**Re: PLUS Review 2016-08-02; Branch Oaks, AKA McKinney's Grove
Response to Comments**

Please allow this letter to serve as our response to agency comments resulting from the PLUS review and meeting referenced above. For ease of review, please note that our responses are shown in red and with the use of a different font.

Figure 1 NRCS soil survey mapping update in the immediate vicinity of the proposed construction

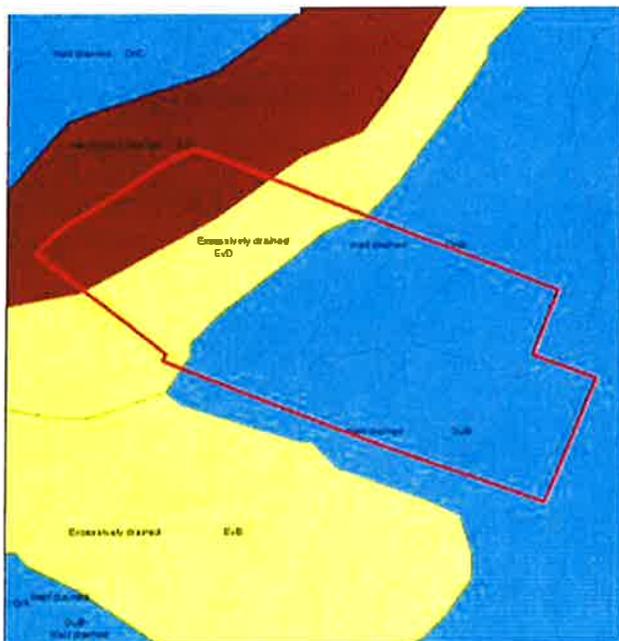
- Based on soils survey mapping update Greenwich-Urban land complex (GuB; 0-5 percent slopes), Longmarsh (LO) and Evesboro (EvD; 5 to 15 percent slopes) are the primary soil mapping units mapped on subject parcel. Greenwich-Urban land complex is well-drained soil mapping units that has been modified through cutting and filling by heavy equipment. Longmarsh is a very poorly-drained wetland associated (hydric) soil mapping unit that has severe limitations for development due to a high seasonal high water table. Evesboro is an excessively well-drained soil with limitations due to steeply-sloping topography (Figure 1). DNREC strongly advises refraining from development in the Longmarsh soil mapping unit and limiting development in the Evesboro soil mapping unit where slopes exceed 10 percent.

DNREC strongly discourages building on hydric soils because they are functionally important source of water storage (functions as a "natural sponge"); the loss of water storage through excavation, filling, or grading of intact native hydric soils increases the probability for more frequent and destructive future flooding events. The probability for flooding is compounded by increases in surface imperviousness as building density in the area increases over time. Moreover, destruction of hydric

It is recommended that the applicant contact a licensed (Delaware Class D) soil scientist to make a site specific assessment (i.e., soil survey mapping) of the soils on this site and avoid building on hydric soils) of the soils in this parcel and a field-based delineation of the hydric soils and/or wetlands. According to information presented in the PLUS application, a wetland delineation has not been conducted to date. A list of licensed soil scientists can be obtained from the Ground Water Discharges Branch; the Branch can be reached by phone at 739-9947.

Response - A Delaware licensed Geotechnical Engineer has provided a Soils report regarding both structural characteristics of the soil as well as soils types and percolation rates for purposes of Stormwater management design.
